USDA FOREST SERVICE - ROCKY MTN. REGION  
GRAND MESA, UNCOMPAGRE, GUNNISON N.F.

# FINAL ENVIRONMENTAL STATEMENT

HOMESTAKE MINING COMPANY  
PITCH PROJECT

Fig. 2.8. Location map for groundwater investigation: mill site. Source: ER Suppl., Plate 2.6-3, p. 2-19.

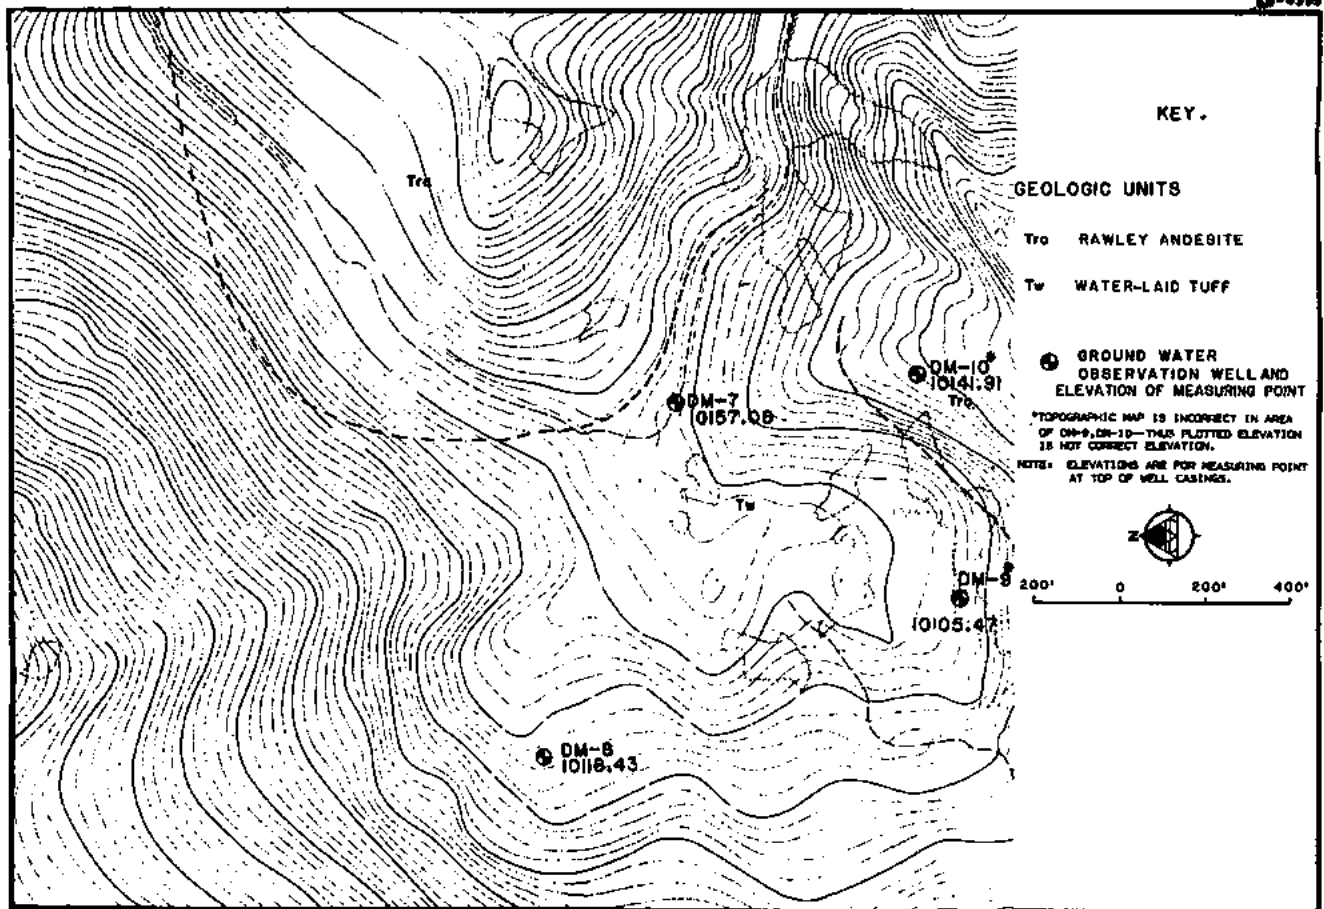
8. Page 2-15, Figure 2.8: The locations of the groundwater sampling stations (GW-1 to GW-7) are not shown in this figure.
9. Pages 2-16 through 2-18, Tables 2.5 and 2.6: What is the explanation for the high TSS concentrations in the groundwater samples listed in Table 2.5? Why isn't the pH included in Table 2.5 or 2.6?

Fig. 2.9. Relationship of Indian Creek and Marshall Creek to project area. Source: ER, Plates 2.6-1 and 3.6-3, pp. 2-127 and 3-45.

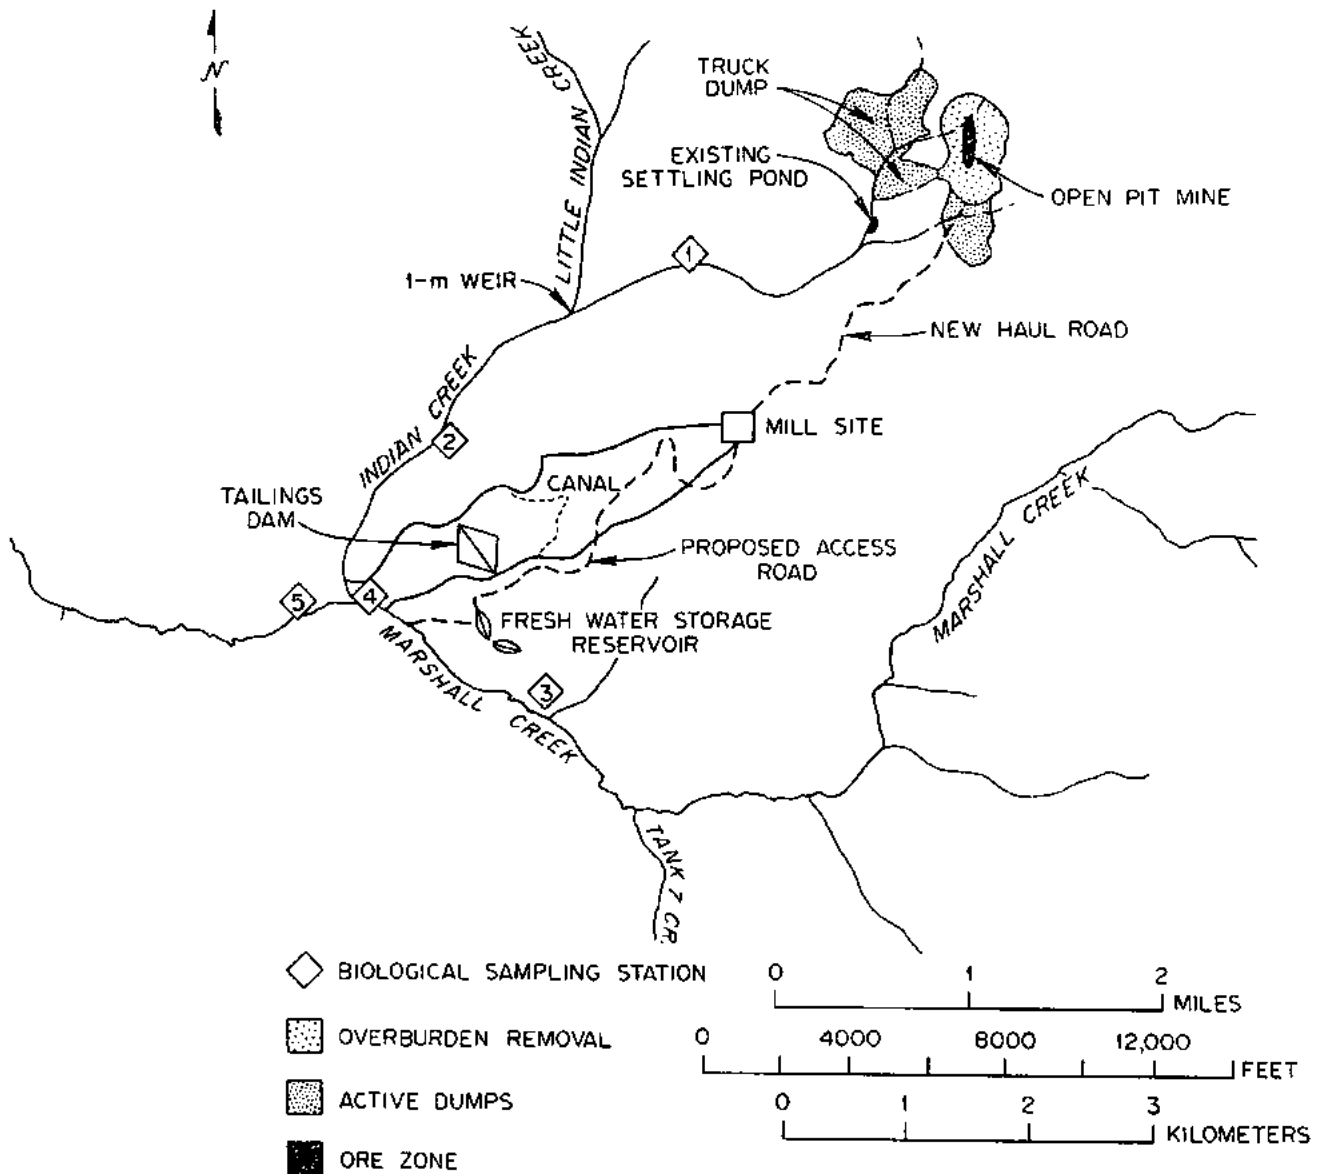
11. Page 2-20, Figure 2.9: The existing Pinnacle Mine operations should be included in Figure 2.9. The text in Section 2 should describe the existing Pinnacle Mine conditions and wastes.

7. The statement is based on personal observations by the staff.
  8. The location of Tank 7 Creek has been added to Fig. 2.9. Additional streamflow information has been added in Sect. 2.4.2.2. Potential impacts have been addressed in Sect. 4.3.3.

11. The Pinnacle Mine is not operating. Groundwater monitoring site GW-3 on Fig. 6.1 monitors the discharge from the Pinnacle Mine portal. The quality of this water is reported in Table 2.6. Figure 2.4 also shows the mine location.

Fig. 3.12. Estimated water balance for Pitch Project.

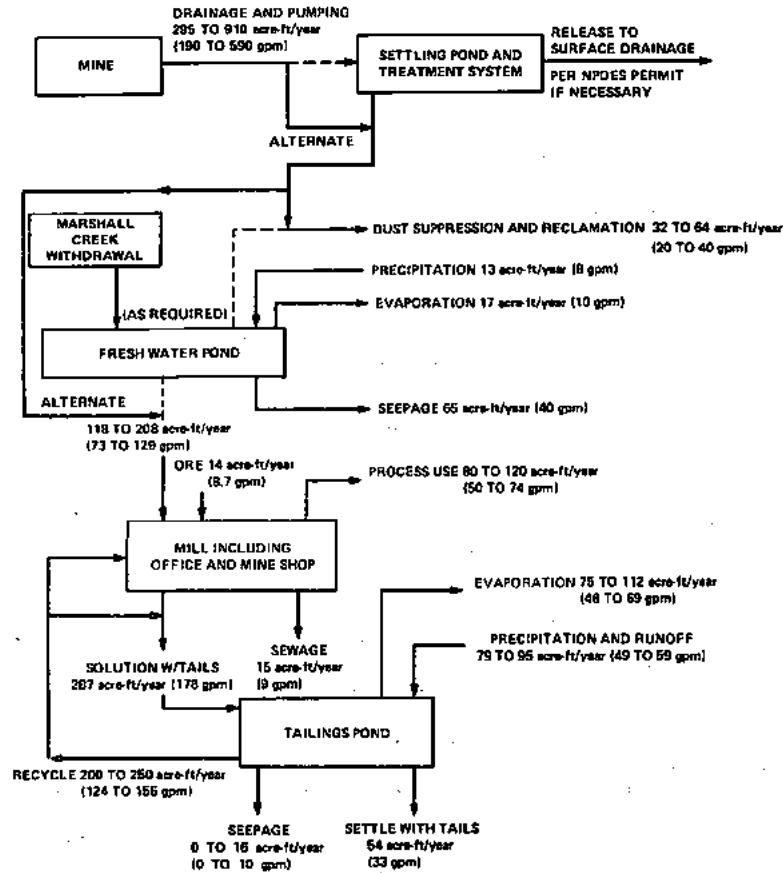
30. Page 3-21, Figure 3.12: Contrary to the texts of the Environmental Report and the DES, the dewatering effluent is depicted as primarily a discharge to surface drainage and only as an alternate mill process water source. Is this correct? The dewatering effluent should be used as an alternate. This will eliminate or reduce treatment costs and decrease the use of Marshall Creek water. What are the units?

39. Page 4-5, Section 4.3.3., Water Use: The statement "The applicant is planning to use recovered mine groundwater as milling process water . . ." is not in agreement with Figure 3.12.

30. Mine water from the open pit will be used in the mill circuit as needed. Only excess mine water that is not used in the mill circuit will be discharged. Prior to discharge, the water will be treated, if necessary, for radium removal and then released to the new sedimentation pond for suspended solids removal. The units referred to in Fig. 3.12 are acre-feet. This figure has been updated. (See response to comment 29 above.)

39. The applicant will use mine water in the milling process. Figure 3.12 has been modified accordingly. Mine water in excess of that required in the mill circuit will be treated for radium removal, if necessary, and released to the sedimentation pond. Fresh water demands will be met using the fresh water storage pond. (See responses to comment 30 above, State of Colorado comment 42, and EPA comments 30 and 45.)

Fig. 6.1. Radiological preoperational monitoring program sampling sites. Source: ER, Plate 6.1-1, p. 6-50.

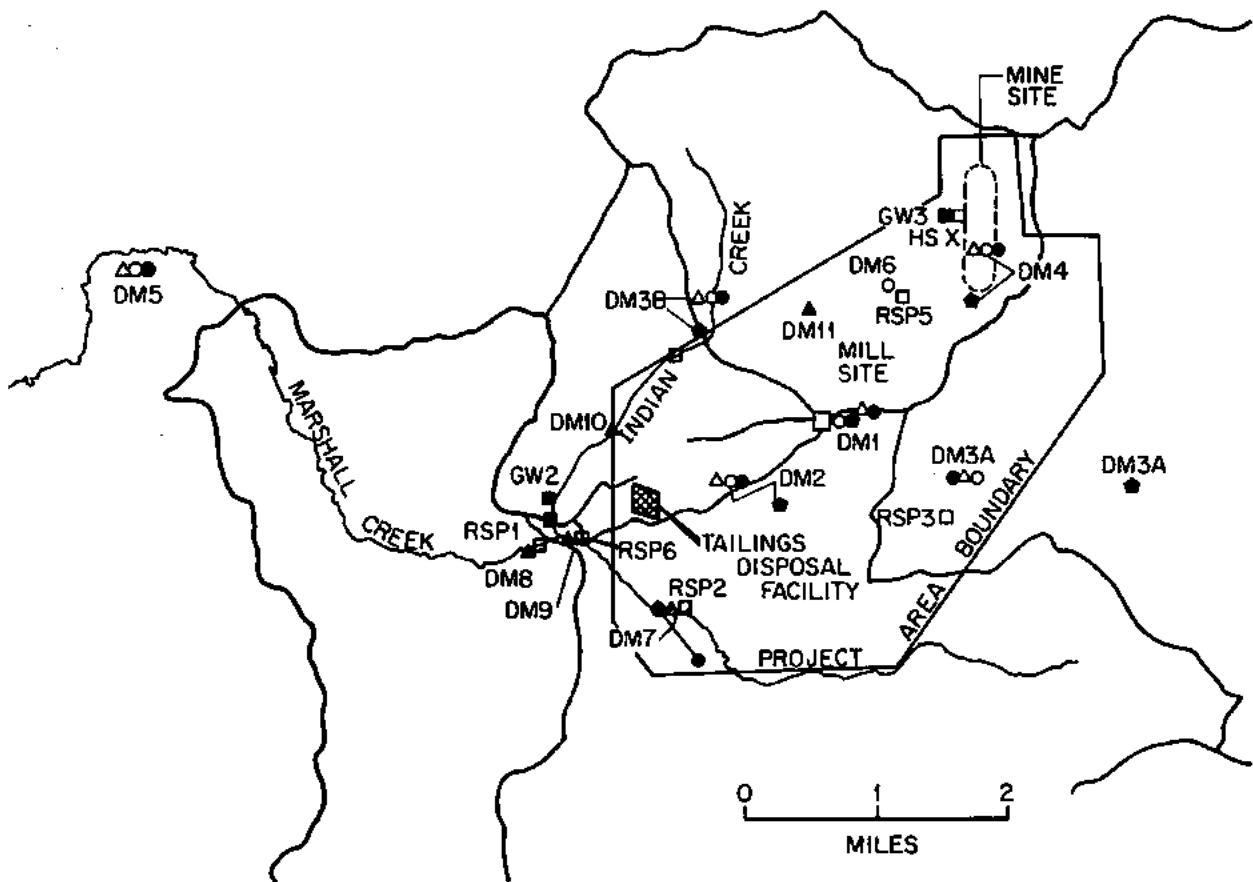
58. Page 6-9, Figure 6.1: This map is difficult to read. It should be enlarged and the contour lines removed. The only required features are the surface drainages and the major sites of the Pitch Project (i.e., mine site, mill site, and tailings disposal pond site). It also would be helpful to illustrate the sampling sites by related types on two additional figures: (a) surface water and sediments, aquatic biota, and ground water; and (b) air, soil, vegetation, and terrestrial animals.

58. Figure 6.1 has been revised to improve legibility.
